ADDRESSEES	: ABC Customer Care and Parts Source Owners and users of vehicles mentioned under "Application"
VEHICLE TYPE	: T2100, C2045, CX..., TX..., TD925US
CONFIGURATION GROUP	: 7.06 Steering – front-axle steering
BULLETIN TYPE	: Safety Recall NHTSA 17V-064/TC 2017-064
DATE	: February 15 th , 2017
SUBJECT	: Replacement of front axle steering system bevel gear
TERMS & CONDITIONS	: Refer to the warranty section further in this Bulletin.

SUBJECT OF BULLETIN : To change bevel gear of front axle steering system

First generation Pailton bevel gear	Second generation Pailton bevel gear (additional dust cover at input and output shafts) (*)

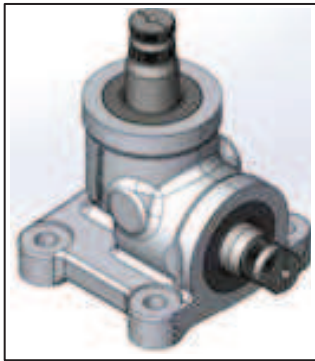
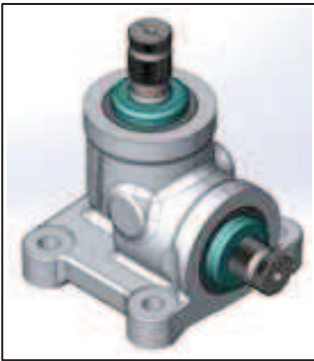
The safety recall, subject of this Bulletin, is applicable to the following coach models equipped with the first generation Pailton bevel gear in the front steering system:

- Van Hool NV noticed a defect related to safety in the first generation Pailton bevel gears.
- The grease in the bevel gear could affect performance at very low temperatures (below -20°C/-4°F). If the grease in the bevel gear becomes hard enough to affect drivability, additional manual force could be required to turn the steering wheel. This would be especially noticeable when the steering wheel is turned the first times after an initial start-up. The phenomenon could disappear later as a matter of course due to the warming up of the grease in the bevel gear.

Additionally it has been determined that in some cases water has penetrated the bevel gear via the sealing thereby contaminating the grease. The penetrating water will start corrosion of the bearings. This problem shows a gradual, but continual increase of the steering forces and will not disappear at higher ambient temperatures or when the bevel gear is in use.

- Owners and operators of coaches equipped with a Pailton bevel gear should first identify their bevel gear. If the vehicle is equipped with a first generation Pailton bevel gear, it must be replaced by a corresponding ZF bevel gear. **The Pailton bevel gears of the second generation are not affected!**

Pailton and ZF bevel gears are interchangeable, but note that the ZF bevel gear has a mid-position which should be taken into account during the installation of the bevel gear.
